October 24, 2007

### STAFF REPORT

#### APPLICATION PRC B-846

#### HUNTER MILL DISTRICT

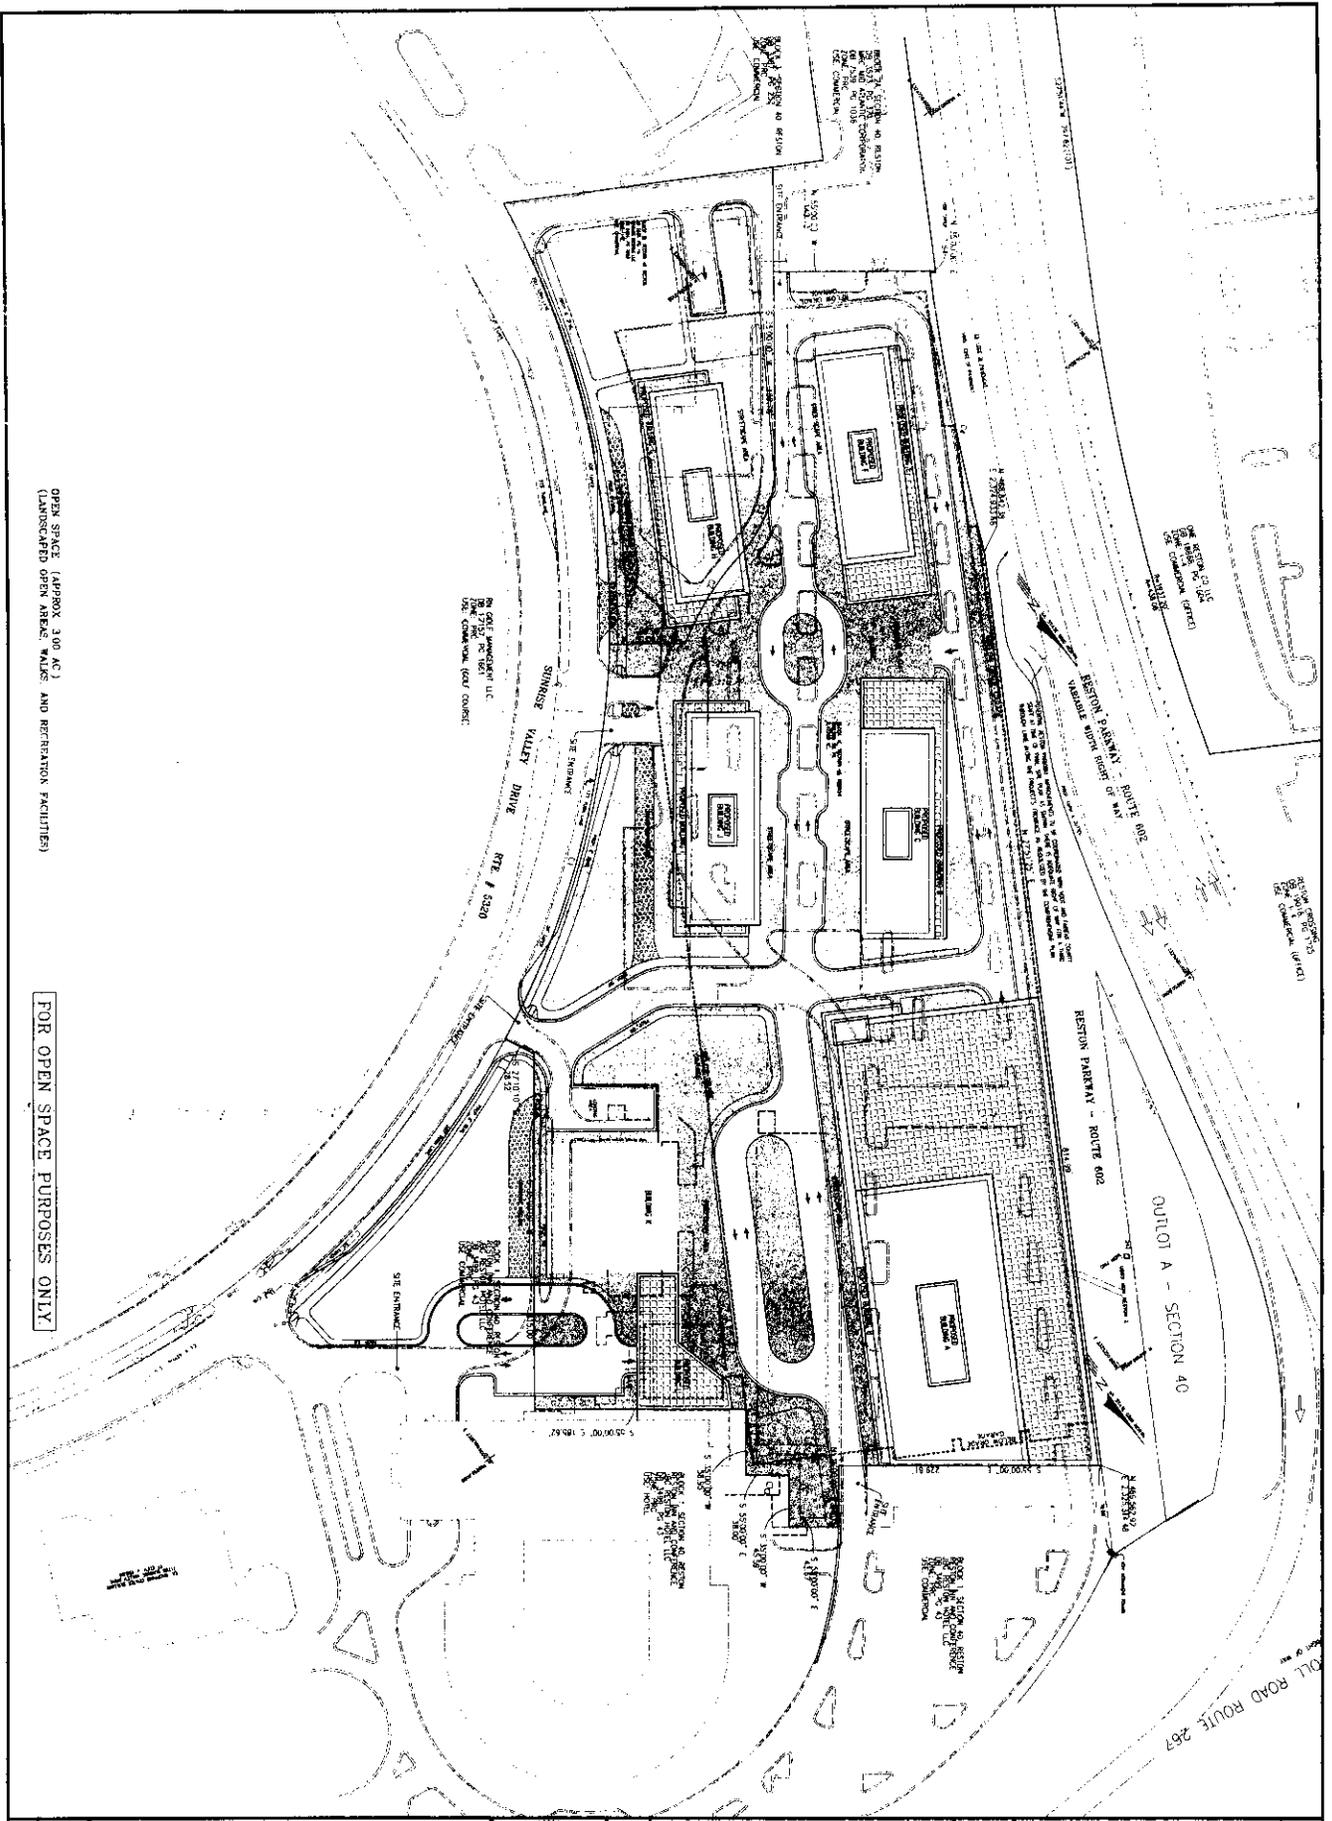
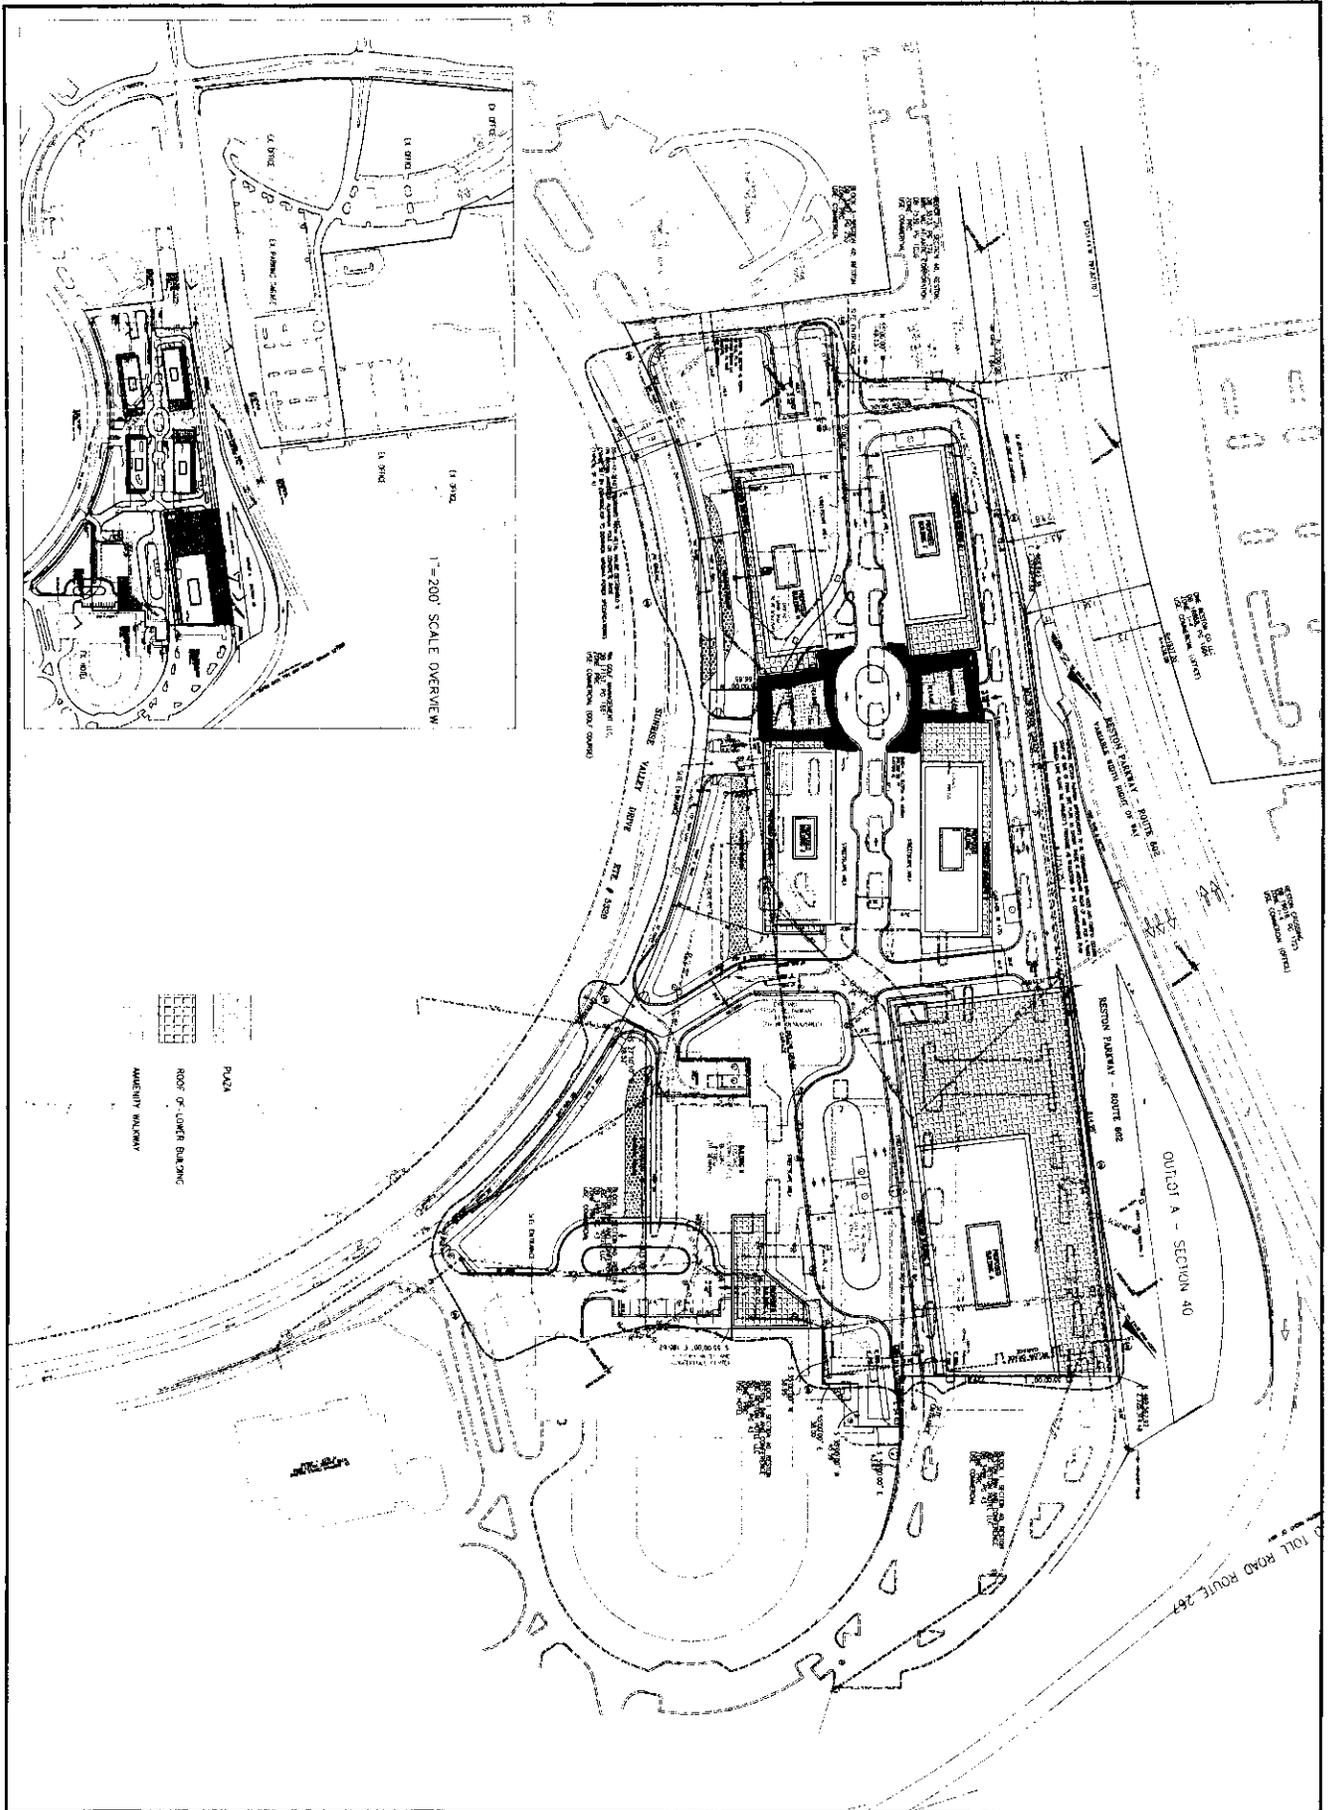
1. **Comment:** Sheets 9 and 10 of this submission generally shows the concept of the landscape plan for the site. It is not clear if trees bordering the interior streets will be planted in isolated or contiguous planting beds, and does not distinguish between pervious and impervious surfaces. Plaza areas and grasspave indicated on sheet 4 appear to conflict in some cases with proposed planting.

The applicant is proposing a public plaza feature within the center of the site. The plans show an area of paving with potential water features. More details on the facilities and amenities need to be provided with the application.
